INCH-POUND
MIL-A-8591H
AMENDMENT 1
30 June 1994

MILITARY SPECIFICATION

AIRBORNE STORES, SUSPENSION EQUIPMENT AND AIRCRAFT-STORE INTERFACE (CARRIAGE PHASE); GENERAL DESIGN CRITERIA FOR

This amendment forms a part of MIL-A-8591H, dated 23 March 1990, and is approved for use by all Departments and Agencies of the Department of Defense.

FIGURE 12. Location of connector on rail launched store.

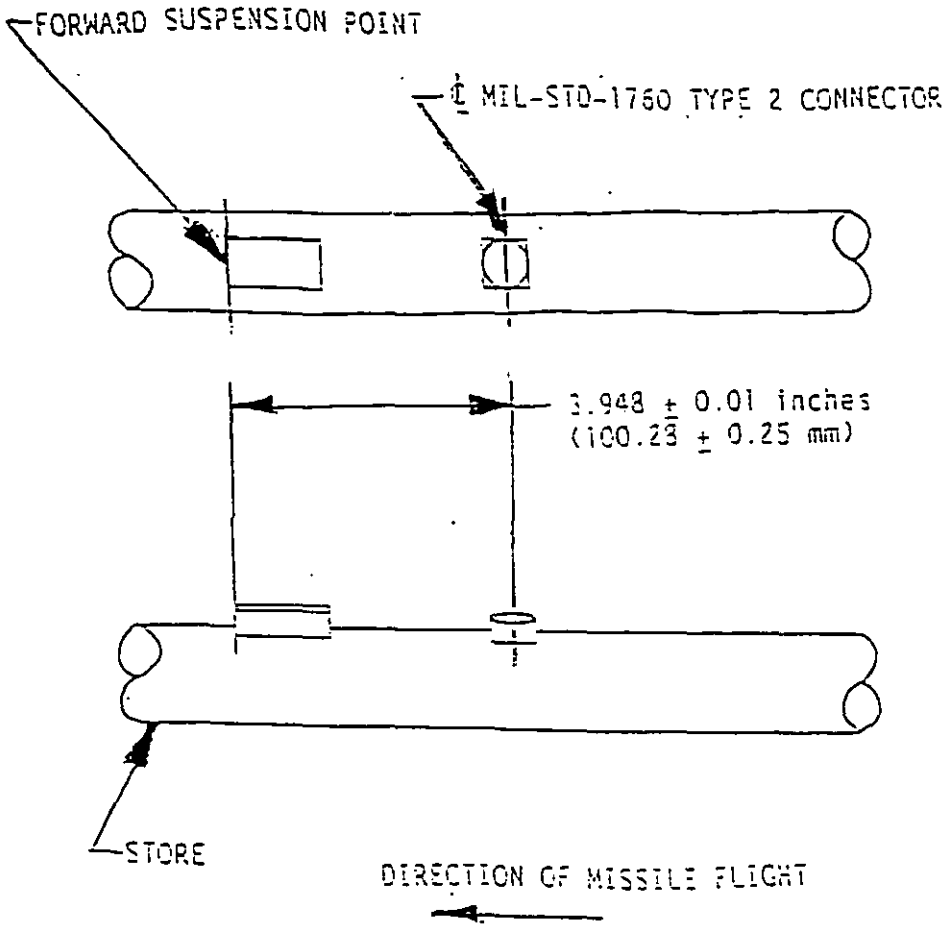
b. The Type 2 connector specified in MIL-STD-1760 is shown on Figures 4, 5, and 6 for blind mate eject launch applications and Figure 12 for rail launch applications.

Add Figure 12 as shown:
